memorandum

Rocky Flats Environmental Technology Site Safety Analysis Report, Revision 0

Wynn A. Harding, Vice President
Safety Systems and Engineering
Kaiser-Hill Company, L.L.C.Reference: Letter, Harding to Klein, 98-RF-02243, dtd 4/29/98, subject: Rocky Flats
Environmental Technology Site Safety Analysis Report, Revision 0 - WAH-
135-98

Figure 2-2. Site SAR Figure 9-6 AB Seismic Risk Perspective

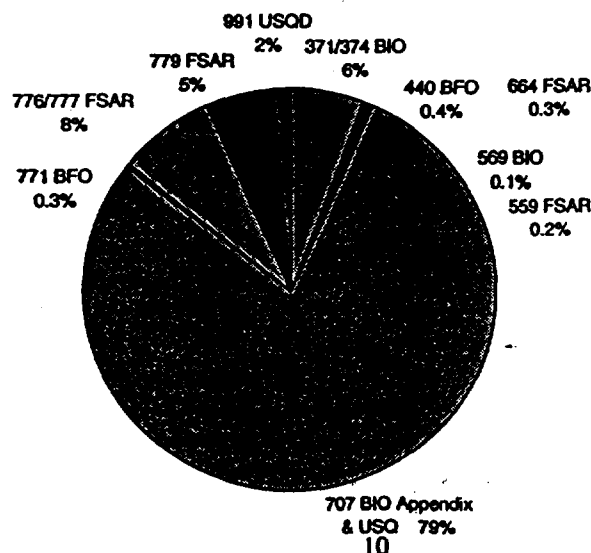
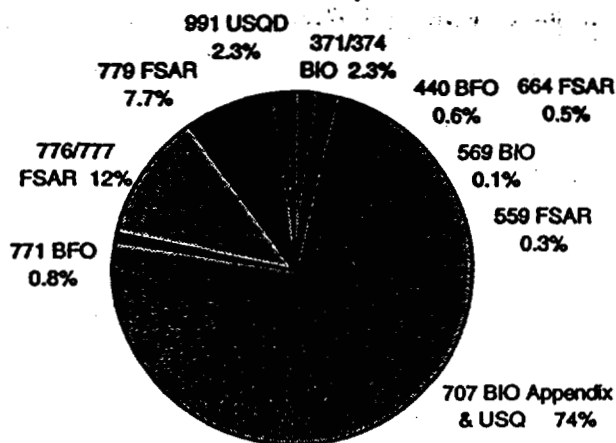
The Site SAR Table 9-20 also presents numerical risk estimates by multiplying the MOI dose by the AB-approved estimate of seismic frequency of occurrence. These bounding point estimates are summed to present a Site composite risk of 0.28 rem/yr (excluding the Building 371/374 Beyond DBE) rather than the median risk estimates discussed earlier (i.e., 0.044 rem/yr for the Baseline case, 0.056 rem/yr for the Closure case, or 0.046 rem/yr 1998 update). Contribution by building to the Site seismic risk composite is presented in a pie chart in the Site SAR Figure 9-6 which is reproduced in Figure 2-2. This perspective includes collapse of Building 371 which is incorrect since it has been confirmed to not collapse due to a 10,000-year Performance Category 4 earthquake. Using the AB-approved data, Building 707/707A is the greatest contributor to seismic risk, the same conclusion as from the realistic risk assessment as shown in Table 2-6 and the Site SAR Figure 9-5, but with a larger contribution (i.e., 79% rather than 44% of the Site composite estimates).

Table 2-8 presents a slightly different perspective based on adjusting the Site SAR Table 9-20 for AB-approved consequences and frequencies. Source terms and dose consequences were adjusted as discussed above for Building 707/707A and Building 771 to reflect the BFO-approved bounding estimate (i.e., Table 9-20 is incorrectly based on the BFO nominal MAR and dose, rather than the bounding estimate established by increasing the nominal consequences for all Scenarios of Concern by 50%). No changes were made to the Buildings 776/777 and 779 estimates for this comparison due to the lack of an AB-approved better estimate. The revised estimates show a reduction in the 209 g plutonium source term to 166 g plutonium, resulting in a MOI dose reduction from 230 rem to 170 rem. MOI risk estimates also are reduced from 0.28 rem/yr to 0.19 rem/yr. These revised consequence and risk estimates as shown in Table 2-8 should be used for future USQDs of discovery issues or proposed changes to address cumulative Site impacts (see later discussion in Section 2.1.2.2 on USQD considerations).

Table 2-8 also shows the contribution by building for the revised calculations. The revised Table 9-20 AB estimates are graphically portrayed in Figure 2-3. Comparing the revised AB estimates to those from the Site SAR (as reproduced in Figure 2-2), Building 707/707A is still the dominant contributor (with 74% rather than 79%). The AB perspective on composite risk to the public is the same as previously mentioned based on the median risk perspective (i.e., risks will be dominated by SNM and residue inventories until facilities undergo deactivation, then by plutonium holdup MAR estimates, and then by TRU waste storage facilities).
